Appendix F

DNR Correspondence Regarding Paul Bunyan Trail

RE: Updated Highway 371 North Improvement Project
Paul Bunyan Trail Impact and Mitigation
Letter of Understanding

RE: Updated Highway 371 North Improvement Project
Paul Bunyan State Trail Impact and Mitigation
Letter of Understanding

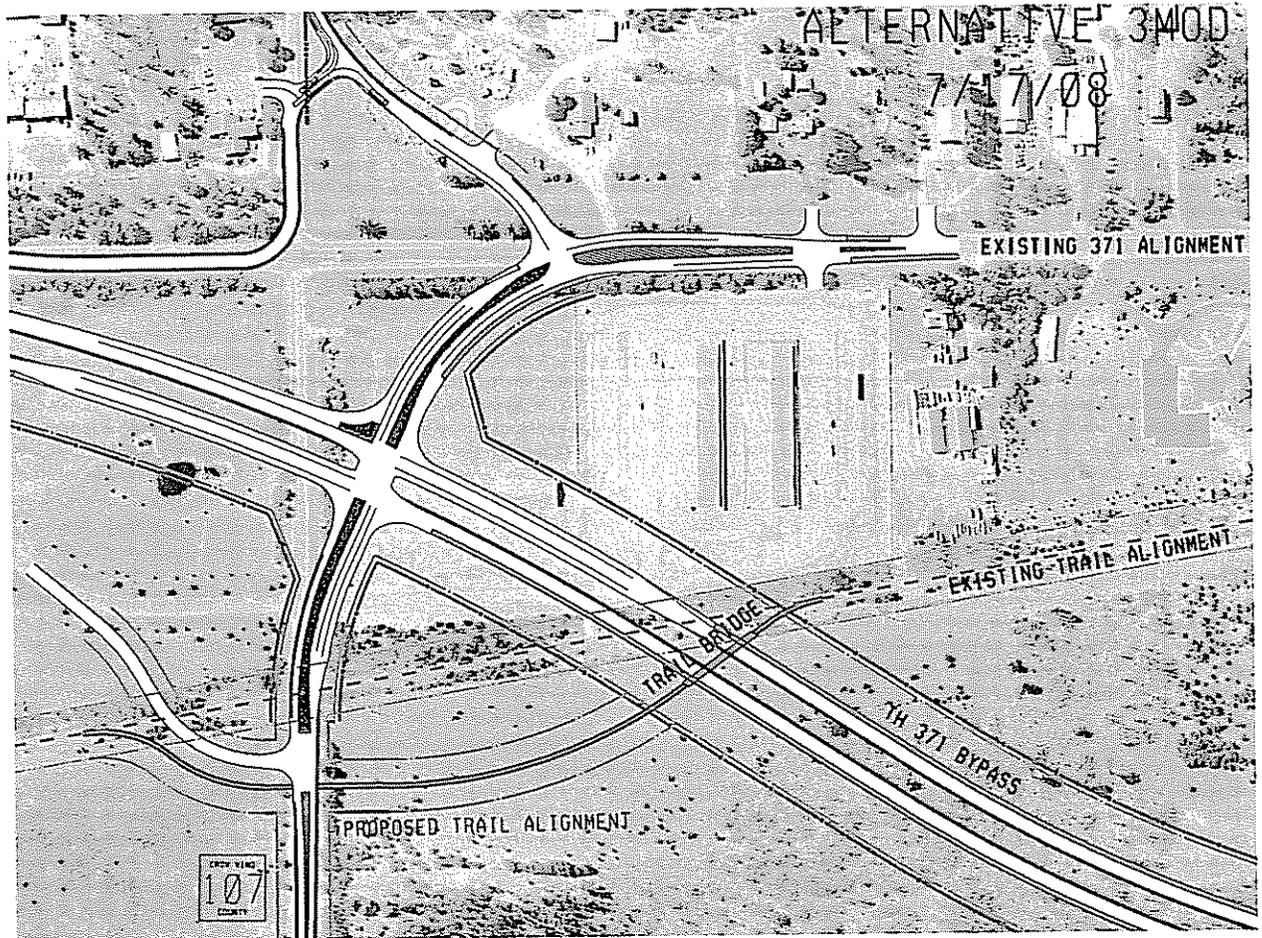
Alternative 3 MOD includes the realignment of Highway 371 in an easterly direction in order to create the Pequot Lakes bypass. By doing so, the new highway alignment will intersect the existing trail corridor and cause an additional 1,450 feet of realignment. Perpetuation of the trail in this location will be accomplished through the use of a bridge structure that spans over the proposed Highway 371 alignment (**See Figure Below**).

Alternative 3 MOD includes the realignment of Highway 371 in an easterly direction in order to create the Pequot Lakes bypass. By doing so, the new highway alignment will intersect the existing trail corridor and cause an additional 1,450 feet of realignment. Perpetuation of the trail in this location will be accomplished through the use of a bridge structure that spans over the proposed Highway 371 alignment.

Regarding the Summary of New Trail Impacts the DNR concurs with the MNDOT proposal as stated.
